## Position on the draft Ecodesign requirements for Servers and Data Storage Products

March 2017

We welcome the opportunity to provide comments on the draft Working Documents on Servers and Data Storage Products, as presented to the Ecodesign Consultation Forum on 17<sup>th</sup> February 2017. The Commission's proposal includes positive elements, such as:

**Table 1– Idle Power Impact of Adding Memory to an HP Server According to HPE Power Advisor Utility**

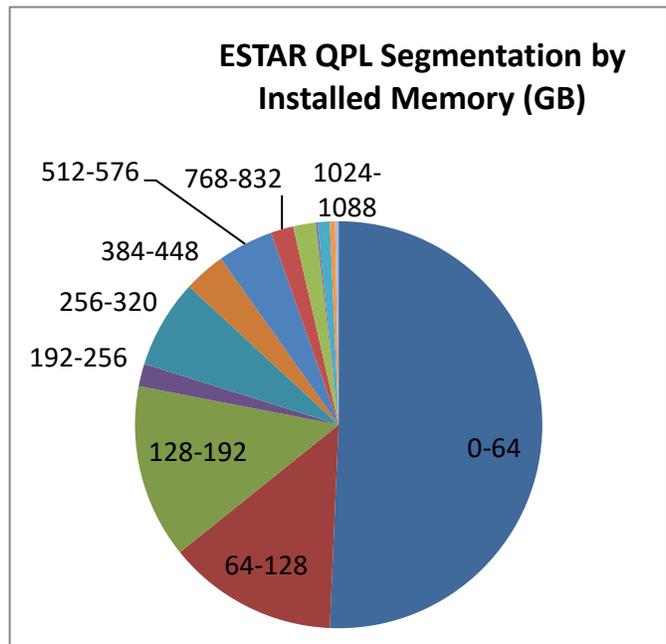
While reduced from the current 0.75 W/GB in ENERGY STAR v2, the proposed memory adder of 0.25 W/GB is still much higher than warranted by today's memory technology. This is evident when using online server configurators like the [HPE Power Advisor Utility](#) which calculate the power increase resulting from adding various amounts of memory to a server. We chose a recent HPE server model ProLiant DL380 Gen9, and configured it with various amounts of memory in addition to the 8GB in the baseline configuration, with results shown in Table 1:

While this is only for one sample server (albeit a mainstream and high-volume product), this exercise suggests that the memory allowance should be around 0.015 watt per GB, less than one tenth that is currently proposed.

**Figure 3 – Correlation of Pass Margin vs. Memory Capacity in QPL**

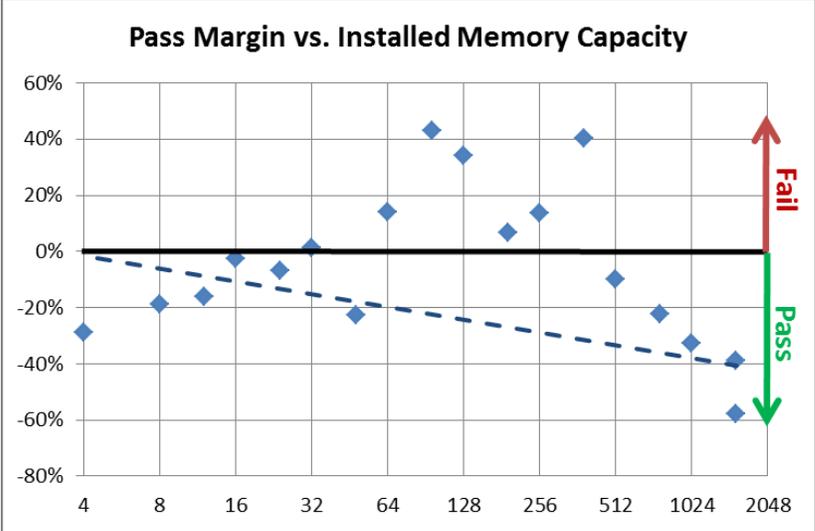
The impact of this memory allowance issue is confirmed by Figure 3 which shows a clear correlation

between pass margin and memory: the more memory, the easier it is for systems to pass, and by a wider margin. This is evidence that memory adders are too high. There should be no significant correlation between pass-rate and memory.

- Preferably use a hyperbolic tangent equation to reflect that power draw does not increase solely by memory capacity, but also by DIMM, and that large capacity DIMMs, while drawing high power than small capacity ones, are more efficient on a per gigabyte basis
- Implement the same concept in a simpler manner, use a 2-step linear allowance, with a proportional allowance of around 0.025 W/GB up to a certain limit (e.g. up to 64 GB, which would cover roughly half of the qualified models), then a linear allowance in the form of 0.015 a + b where a is the memory capacity in GB for a > 64 GB.
- Only use a linear equation 0.015 W/GB. While this may make it harder for low-memory configurations to pass compared to option 2, Figure 3 shows that low-memory configurations already pass by a wide margin.

Figure 4 – 80-PLUS 230V

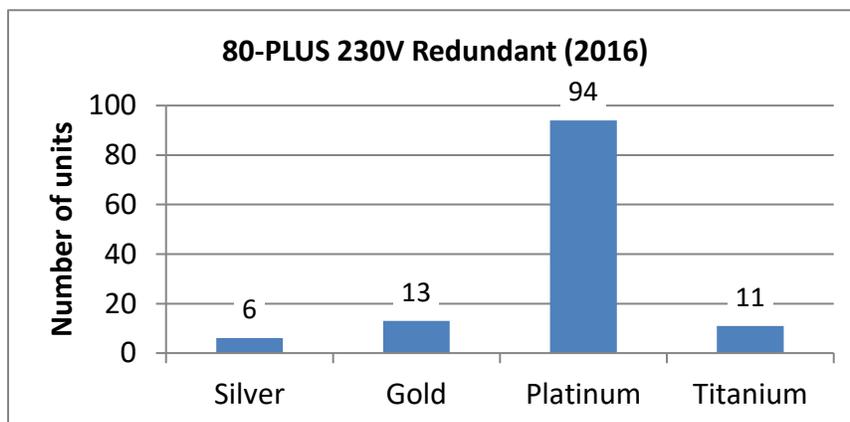
The Commission’s proposal is appropriately ambitious and achievable. The Commission’s proposal corresponds to 80 PLUS Gold for 2019, Platinum for 2023 and Titanium for 2026. A large share of the market already achieves these requirements today. Figure 4 shows that **75 percent** of new redundant

power supplies certified with 80 PLUS in 2016 achieved the Platinum level, which will only be required in 2023. Titanium models represented just short of 10 percent.

This is evidence that the requirements are feasible, and could be implemented earlier than proposed. Should the current timeline be kept, we strongly encourage the Commission to maintain the Tier 3 requirement for Titanium-level efficiency, in order to give industry a strong policy signal that will help them make the engineering investments necessary to achieve these requirements in the most cost-effective manner.

In addition, we recommend the Commission **to implement the 10% load requirement in 2023** instead of 2026, and strengthen it in 2026. Low-load efficiency is the most important load point for servers, as they spend the majority of their time and energy at low utilisation levels (per preparatory study Task 3). In addition, redundant power supplies have even lower loads (for example, they might share the load and therefore have half the load of a non-redundant PSU). At the same time, in order to reduce the burden on industry where it does not yield significant savings, the Commission could potentially slightly reduce the stringency of the requirements at full load since servers spend very little time working at more than 50% load. This would increase energy savings while adding no net burden on industry.
